**SUBJECT: Building 326 Storefront Window Replacement, Partition
Bracing and Isolated Siding Painting
CONTRACT NO. 071543**

ADDENDUM NUMBER # 01

BUILDING 326 STOREFRONT WINDOW REPLACEMENT, PARTITION BRACING AND ISOLATED SIDING PAINTING

COURTYARD FLOOR PLAN

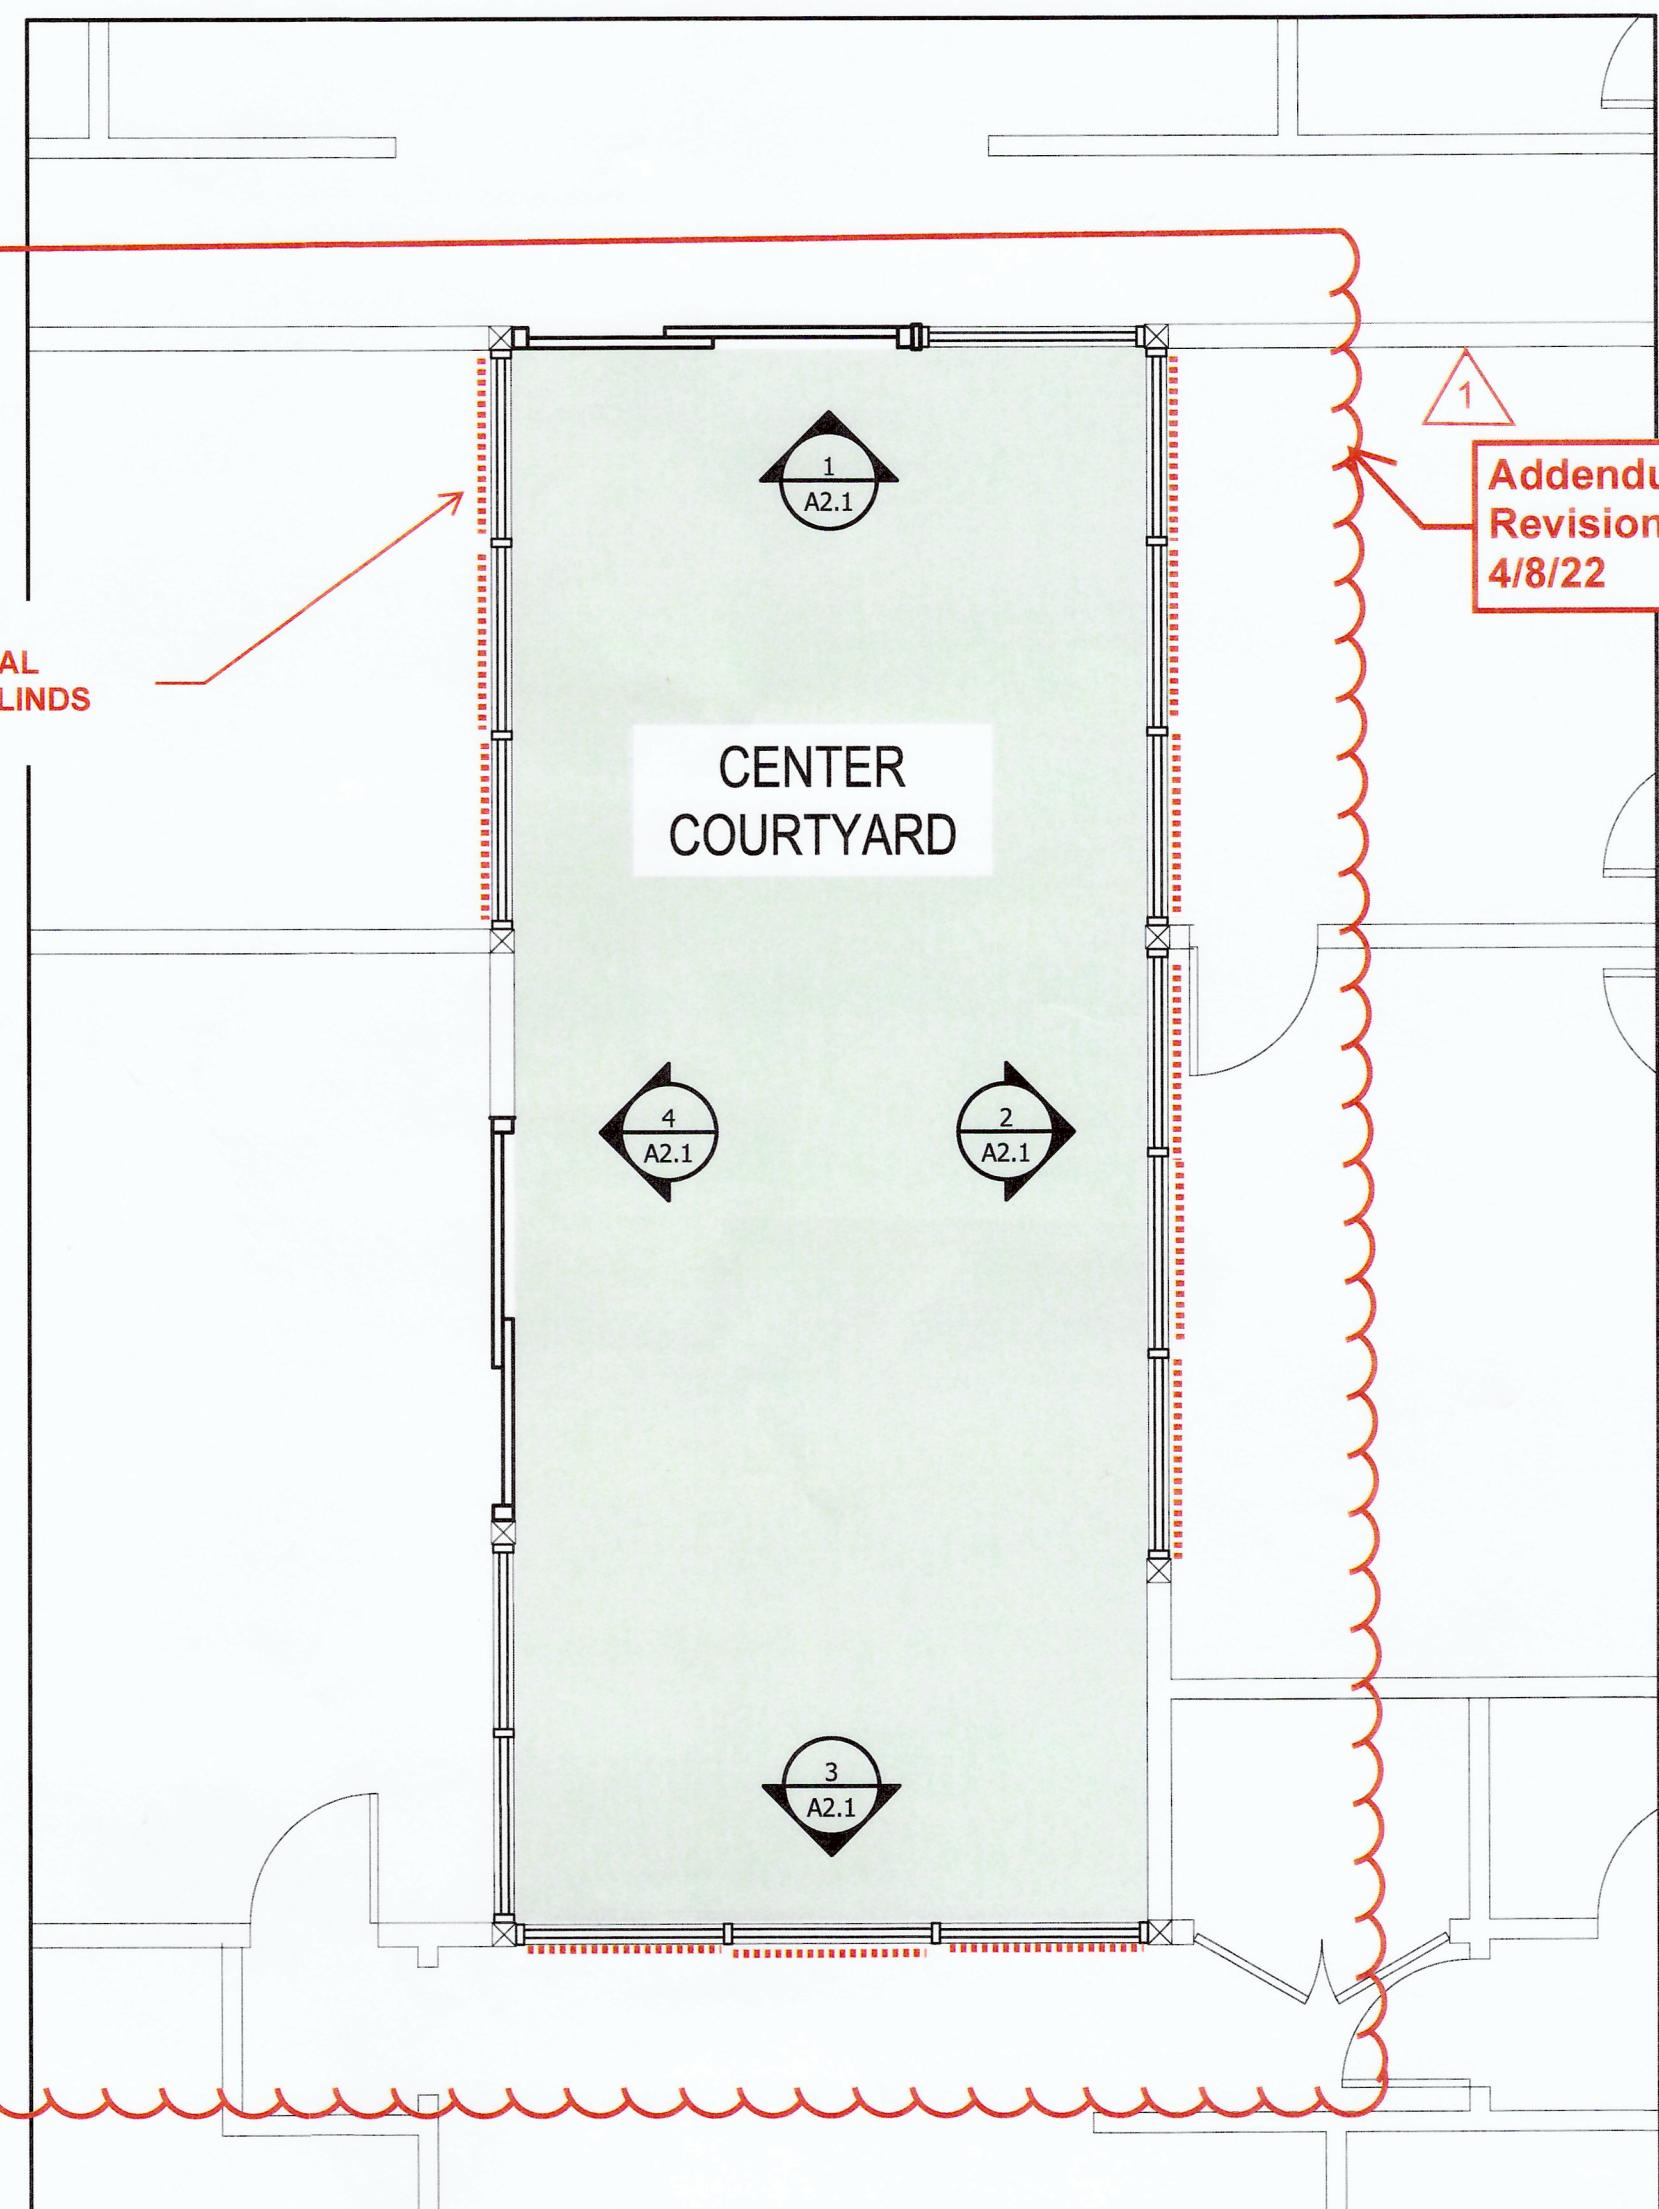
- Added replace horizontal louver blinds, typical.
